Satellite megaconstellations will threaten space-based astronomy

Corresponding Author: Dr Alejandro Borlaff

Version 0:

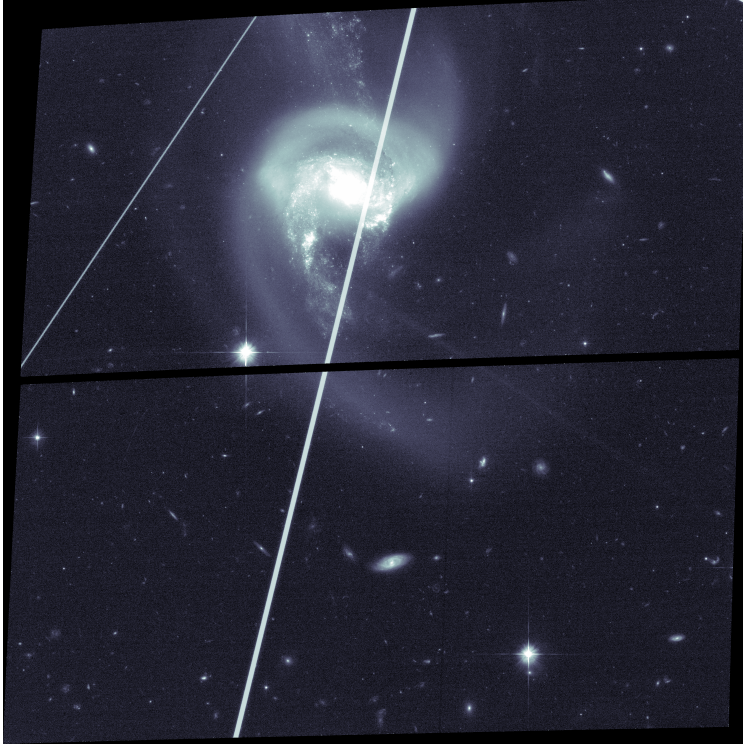
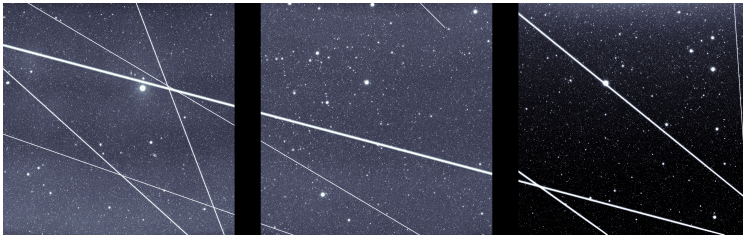
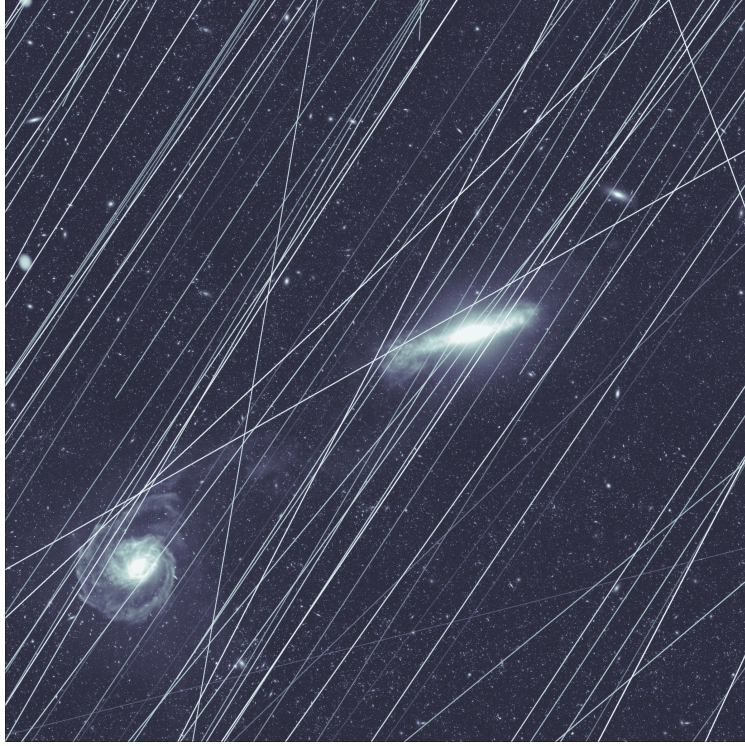
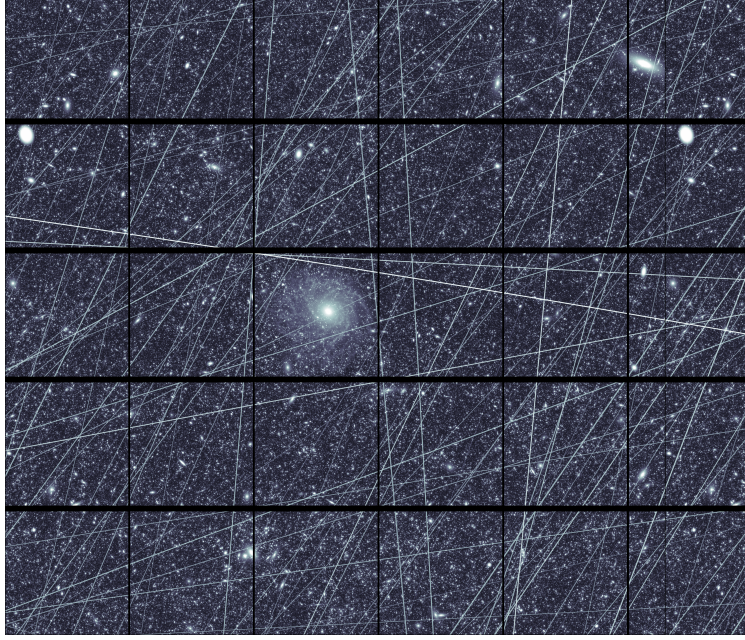
14. Figure 2: Please clarify that these are illustrations for some representative observation simulations (i.e. that such simulation was not performed for all the simulated observations). It would also be useful to represent the whole field of view (possibly as a drawing rather than a full simulated image) with a box indicating the position of the zoomed detail.

Answer: The figures are representative simulations meant to illustrate the effect in the images. Full image simulations were not rendered for each one of the 3000 simulations per telescope. We modified the caption in Figure 2 to specify that the panels represent affected sections from the total simulated exposure. Due to the size of the images – specially for *Xuntian* – it is impractical to represent the full field-of-view in the panels in the main text. We attached them as additional figures to the referee report (see Figs. 1,2,3, and4), and as part of the Supplementary material. Following the suggestion of the referee we made the full figures available as additional material in a Zenodo repository, with the databases containing the properties of the satellite trails (doi:10.5281/zenodo.15707680). The

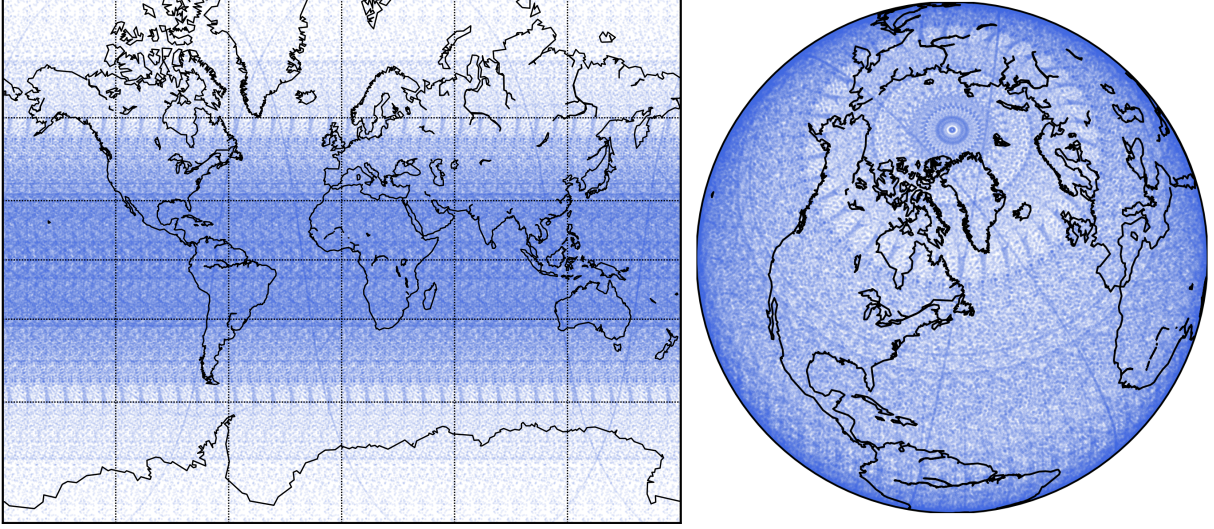
7. Please include information related to Section 3.2 in a similar fashion as done by Lawler+21 (your ref 29) in their Figure 1 and Table 1. This will both enable readers to reproduce the satellite population simulation and verify that it is physically realistic. I note that their paper included a public GitHub repository that could be used to create a potentially more realistic simulated satellite population: <https://github.com/hannorein/megaconstellations/>. I strongly recommend a similar repository to accompany this paper, since all the Figures tell a compelling and urgent story that is rapidly changing over time.

Answer: We have included a new figure and a table in the manuscript following this suggestion. Table 4 of the new version of the manuscript contains the number of satellites (N_{sat}), inclination (i), and orbit altitude (h) for each layer of each constellation. Figure A.1. (also attached here as Fig. 1) represents the projected

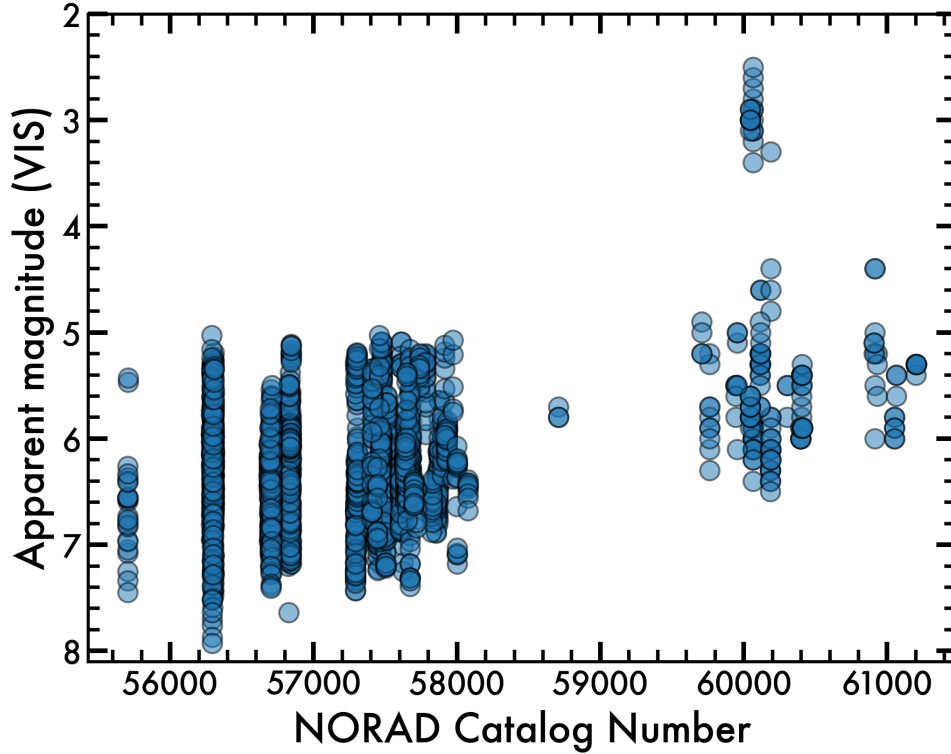
4. While it is true that DTC satellites are larger and inherently brighter, some argue this is effectively offset by choosing lower orbits, because they have a lower peak brightness as seen by telescopes with large primary mirrors. As you well know, this

is because lower objects move faster and appear more out-of-focus. I suggest briefly acknowledging these complex tradeoffs in Section 1 around lines 65-69.
